**METROPOLITAN GOVERNMENT OF NASHVILLE AND DAVIDSON COUNTY**

**STAFF RECOMMENDATION**  
**1825 4<sup>th</sup> Avenue North**  
**April 15, 2015**

**Application:** New construction—addition and outbuilding; Setback determination.  
**District:** Salemtown Neighborhood Conservation Zoning Overlay  
**Council District:** 19  
**Map and Parcel Number:** 08108029400  
**Applicant:** Kyle Keaffaber  
**Project Lead:** Melissa Baldock, melissa.baldock@nashville.gov

<p><b>Description of Project:</b> Application is to construct a rear addition and an outbuilding. The outbuilding requires a setback determination for its rear setback.</p> <p><b>Recommendation Summary:</b> Staff recommends approval of the project with the following conditions:</p> <ol style="list-style-type: none"> <li>1. Staff approve the roof color and masonry color, dimensions and texture.</li> <li>2. The HVAC shall be located behind the house or on either side, beyond the mid-point of the house; and</li> </ol> <p>With these conditions, staff finds that the project meets Sections III., IV., and V. of the <i>Salemtown Neighborhood Conservation Zoning Overlay: Handbook and Design Guidelines</i>.</p>	<p><b>Attachments</b></

**1 1ST FLOOR DEMO**  
SCALE: 1/8" = 1'-0"

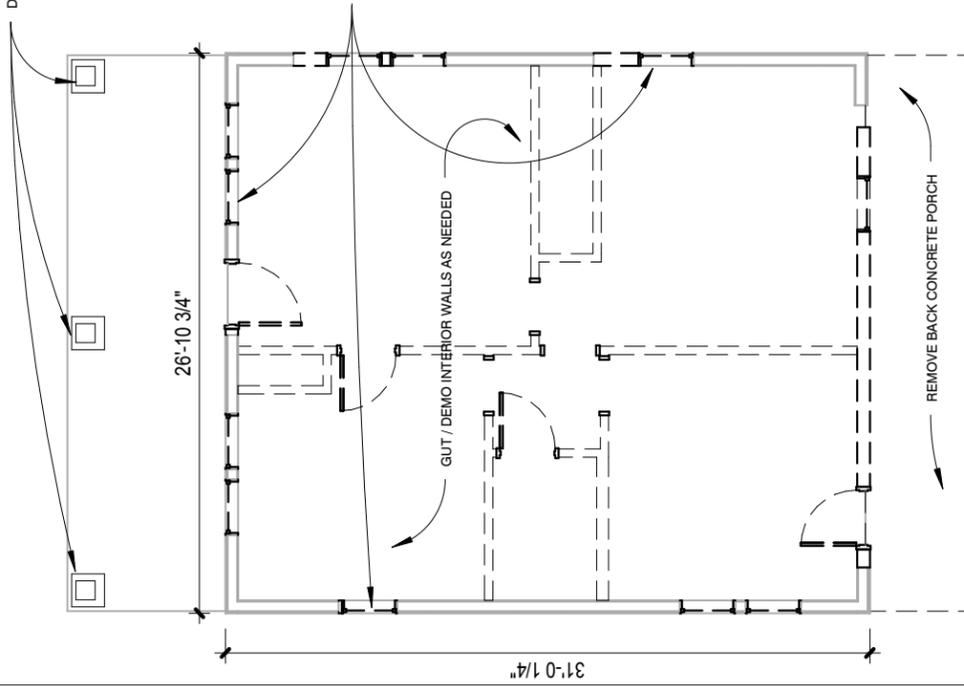
Partial Demolition: The applicant is proposing to remove one window opening on the west/right façade (Figure 2). Currently, there is a double window opening, and the applicant plans to remove one of the windows. Because the window is located at the back of the side façade, staff finds that its removal will not greatly affect the historic character of the house. Staff therefore finds that the project meets Section IV.B.2. for appropriate partial demolition and does not meet Section IV.B.1. for inappropriate demolition.

**1 ROOF PLAN**

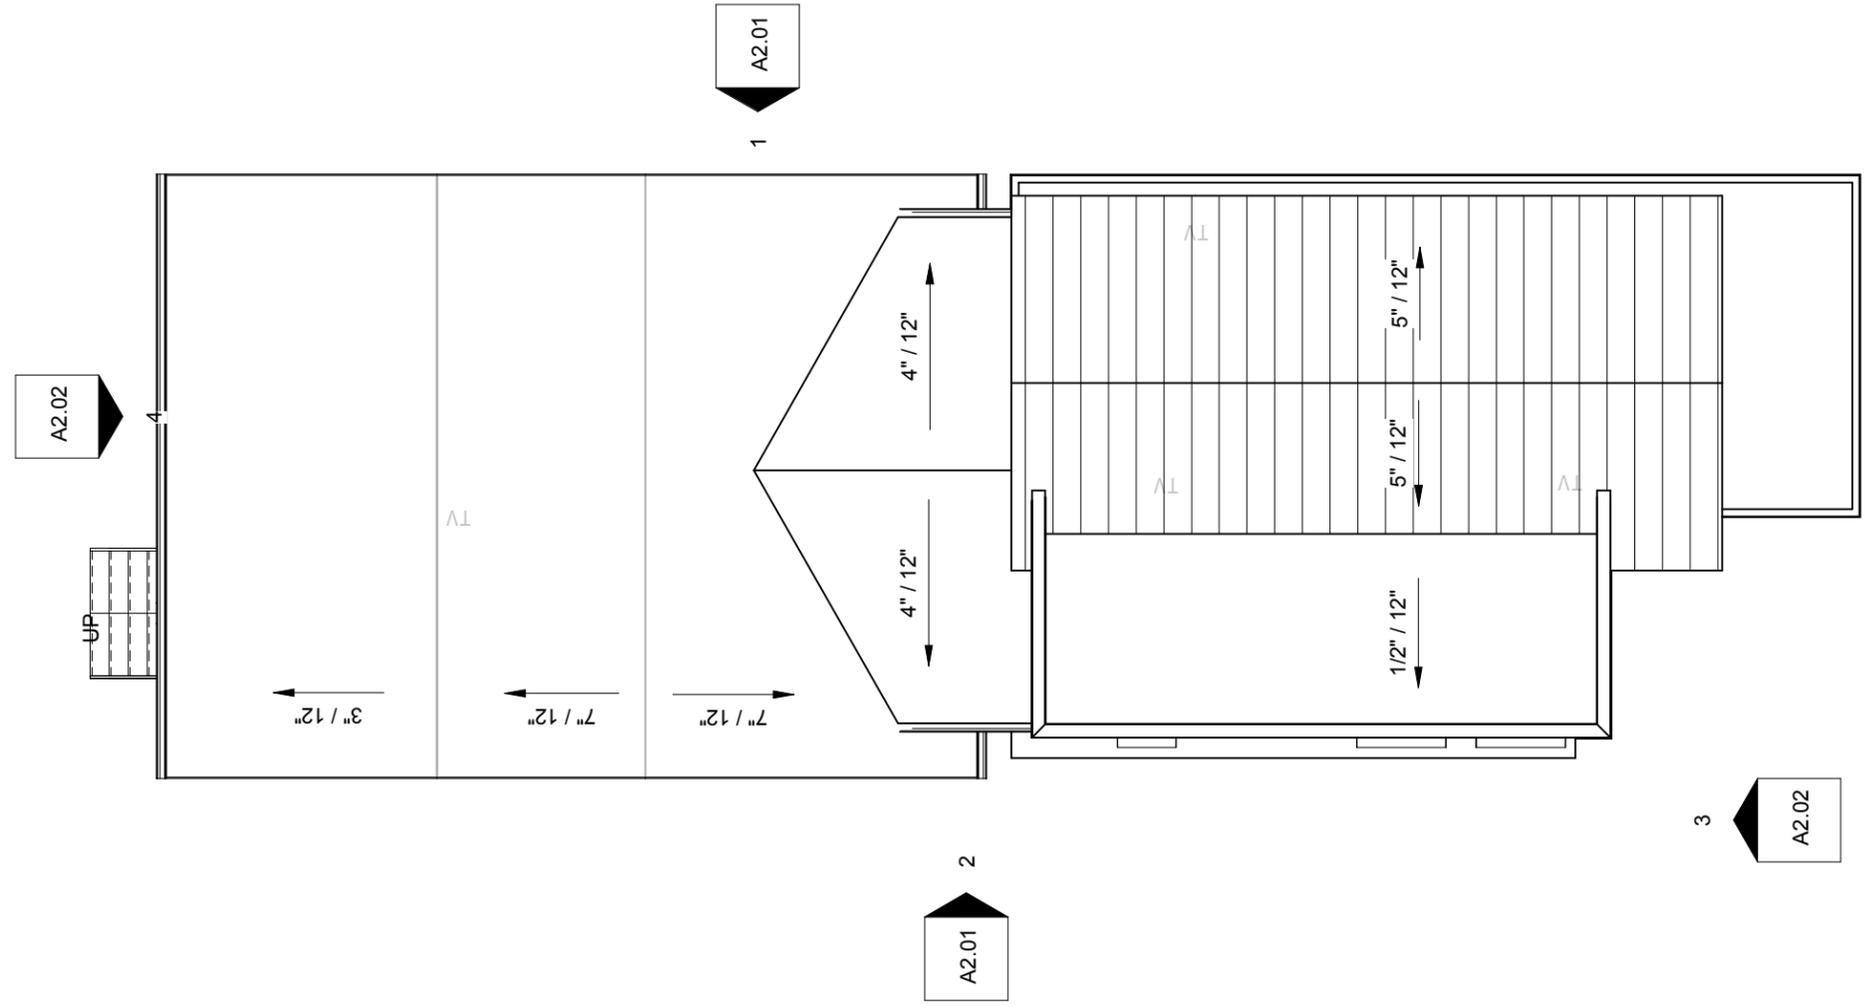
Roof form: The existing house has a side gabled roof form with a slope of 7/12. The proposed addition will have a more modern roof form. It will have a front facing gable with a slope of 5/12, and a portion of the roof will be flat. Although the design guidelines states that roof slopes should be between 6/12 and 12/12 and shall not contrast greatly with the historic roof, staff finds the proposed roof form to be appropriate in this instance because there are non-historic flat roofs in the district, and the roof form helps to distinguish the historic house from the new addition. (Salemtown is the only district

where non-contributing buildings may provide some context.) Staff finds that the project's roof forms meet Sections III.E. and IV. of the design guidelines.

**1 EAST ELEVATION**  
SCALE: 1/8" = 1'-0"

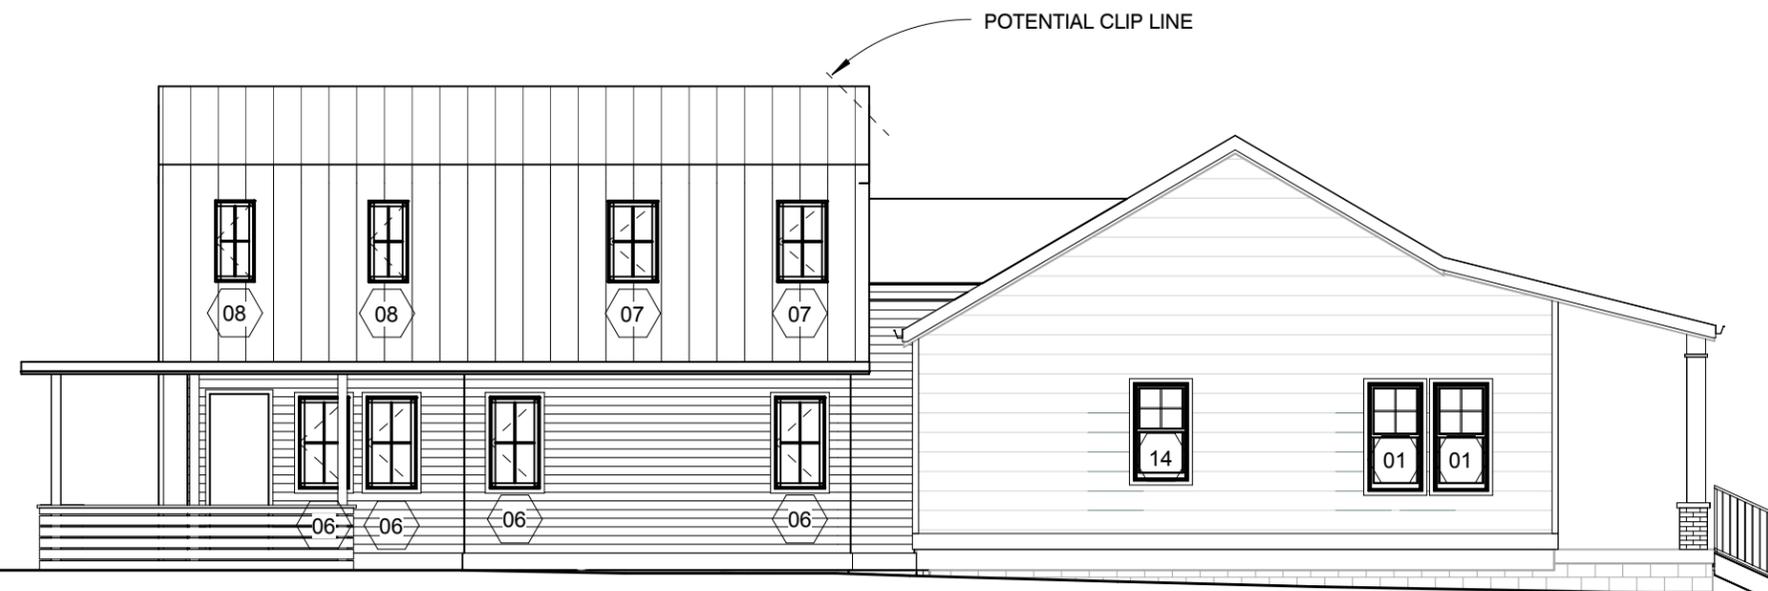
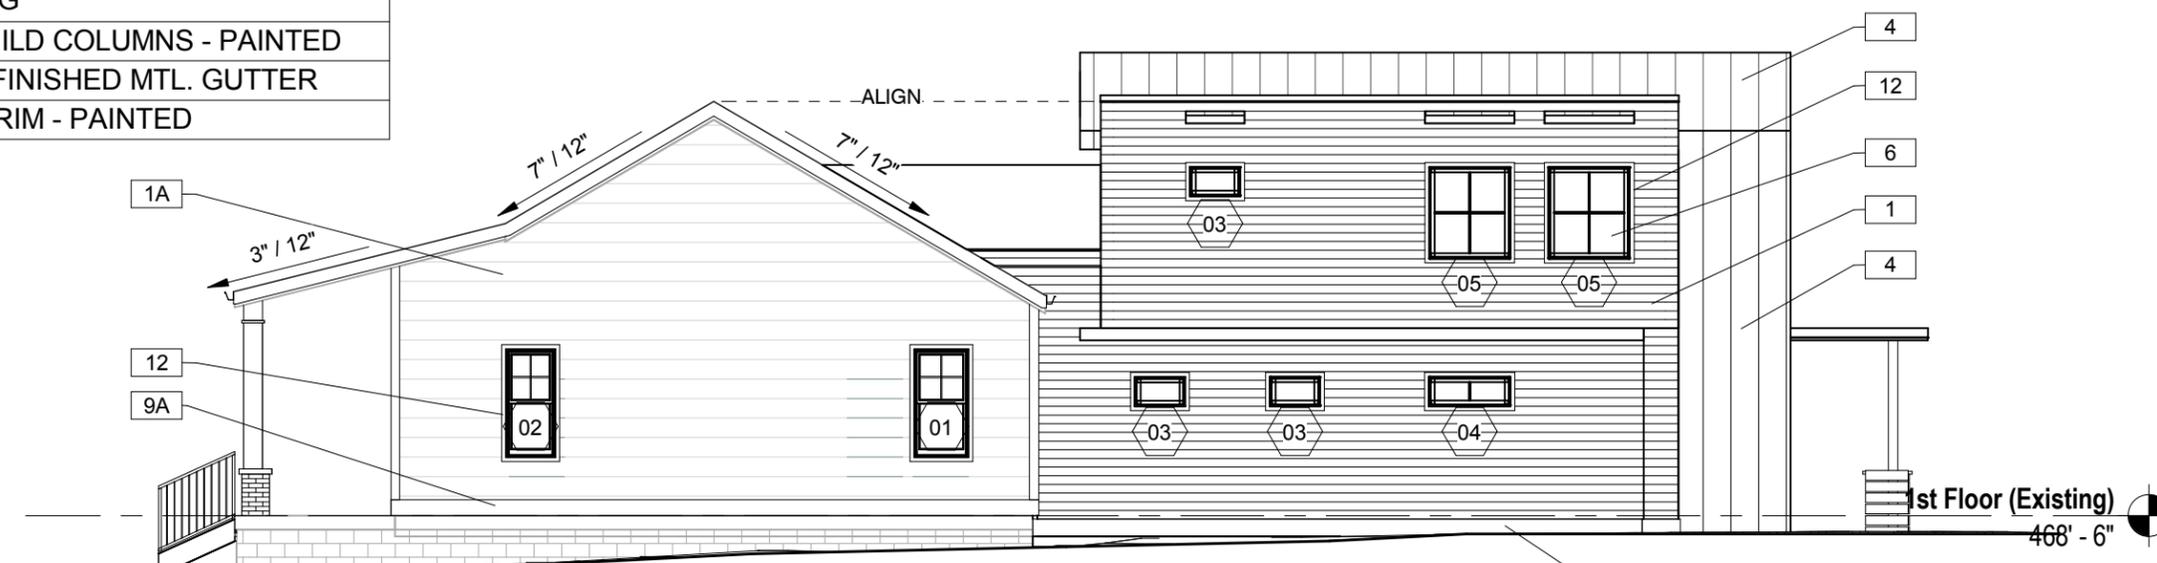
Location & Removability: The addition is located entirely behind the historic house, and is appropriately inset. The addition's roof will connect to the back slope of the historic house's roof about five feet (5') below the historic ridge, preserving at least half of the back slope of the historic roof. This lower roof connector and the insets ensure that if the addition were to be removed in the future, the primary form and character of the historic house could still be discerned. Staff therefore finds that the project meets Section II.B.2.a. and f. of the design guidelines.

Design: The design of the addition is contemporary, distinguishing it from the historic structure and reflecting the addition's 21<sup>st</sup> century date of construction. At the same time, staff finds that the addition's roof form, window proportions and pattern, height, and scale are all compatible with the historic character of the historic house. Staff therefore finds that the project meets Section II.B.2.b.-e. and g.

Height & Scale: The proposed rear addition is appropriately inset two feet (2') from each of the back walls of the historic house. On the west/right side, the entirety of the addition is inset two feet (2'). On the east/left side, the addition steps back out to match the line of the historic house. The bulk of the addition is approximately thirty-feet (30') deep, but a rear covered porch will extend another eight feet, ten inches (8'10") into the rear yard. The addition will add approximately eight hundred and sixty (860 sq. ft.) of footprint to the house, which currently has a footprint of approximately one thousand and fifty square feet (1,050 sq.ft.).

The addition will be two stories in height behind a one-story house. The addition will rise in height to be three feet, three inches (3'3") taller than the historic house. The taller portion of the house will not occur until more than forty feet (40') behind the front of the house, reducing its visibility. It is significantly inset from the historic house, and the taller portion will be just eleven feet (11') wide. Its roof will be gabled. Although the design guidelines ask that the roof form of the taller portion of the addition be hipped, side gabled, or clipped gabled, staff finds the front-facing gable to be appropriate in this instance because such a small portion of it will rise above the historic house's roof line. It will be only minimally visible. In addition, because the roof of the addition will be metal, clipping it may in fact increase its perceived visibility.

The addition will primarily be clad in smooth-face cement fiberboard with a five inch (5") reveal. The trim will be wood or cement fiberboard. The roof will be metal, and staff asks to approve the color and texture of the material prior to purchase and installation. On the second story, east/left elevation, the roofing material will wrap down to the second story façade. The roofing material will clad an entire wall on the west/right elevation, but this part of the addition is inset over nine feet (9') from the side of the historic house and will at most be minimally visible. Although not typical of historic structures, staff finds the use of the metal roofing material as a façade accent material to be appropriate in this instance because it is a modern interpretation of a change in material from first and second story that is part of many historic structures. In addition, because the addition will be over forty feet (40') back, its visibility will be minimized.

Proportion and Rhythm of Openings: The windows on the proposed addition's east/left elevation are all generally twice as tall as they are wide, thereby meeting the historic proportions of openings. On the west/right elevation, there are several horizontal window openings, which the design guidelines discourage on new construction. However, staff finds these to be acceptable in this instance because they will occur over forty-five feet (45') behind the front of the house and will be inset two feet (2') from the line of the historic house. As such, they will be at most minimally visible. There are no large expanses of wall space on the addition without a window or door opening. Staff finds the project's proportion and rhythm of openings to meet Sections III.G. and IV. of the design guidelines.

Staff finds that the addition's height and scale meet Sections III.A., III.B., and IV. of the design guidelines.

GARAGE ELEVATION

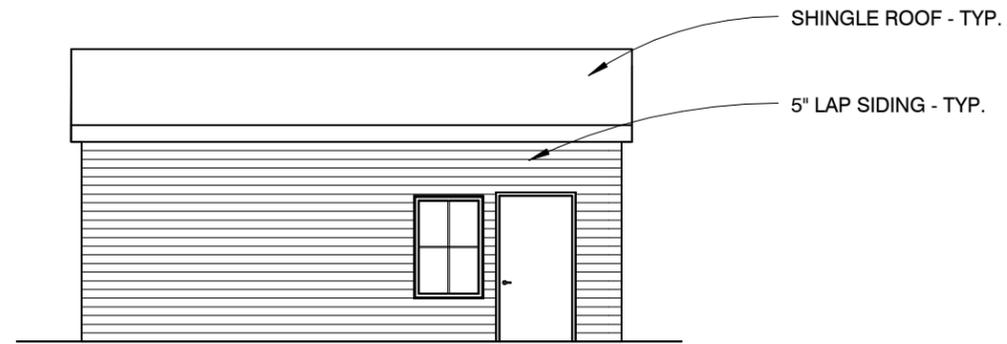
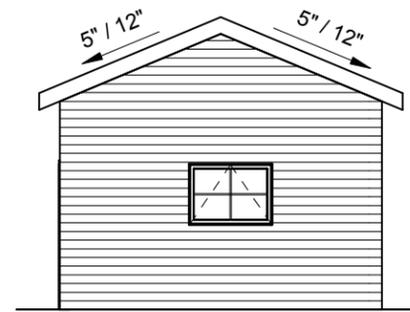
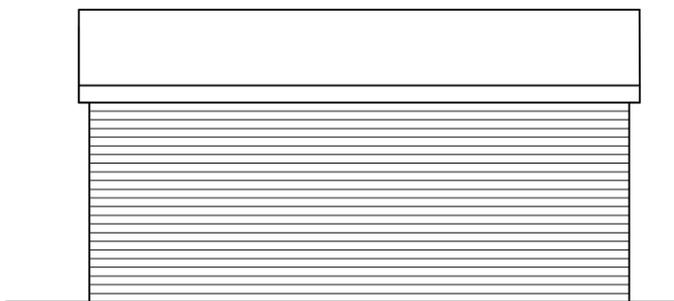
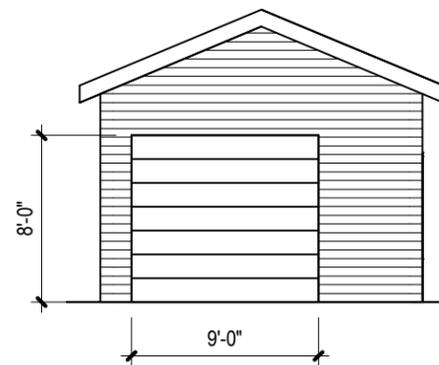
Outbuildings: The applicant is proposing a one-story, one-bay outbuilding. (The outbuilding will not include dwelling space.) See attached "Outbuilding and DADU Worksheet" for the specifics as to how the outbuilding meets the design guidelines. The outbuilding does require a setback determination. Base zoning requires that the outbuilding be ten feet (10') from the rear property line, and the applicant is proposing to locate the outbuilding just five feet (5') from the rear property line. Staff finds that the proposed setback of five feet (5') is appropriate because historically, outbuildings were located close to or on the rear property line. In addition the Metro Map shows that there are several existing outbuildings nearby that sit five feet (5') or less from the rear property line. Staff finds that the proposed outbuilding meets Section III.H. of the design guidelines.
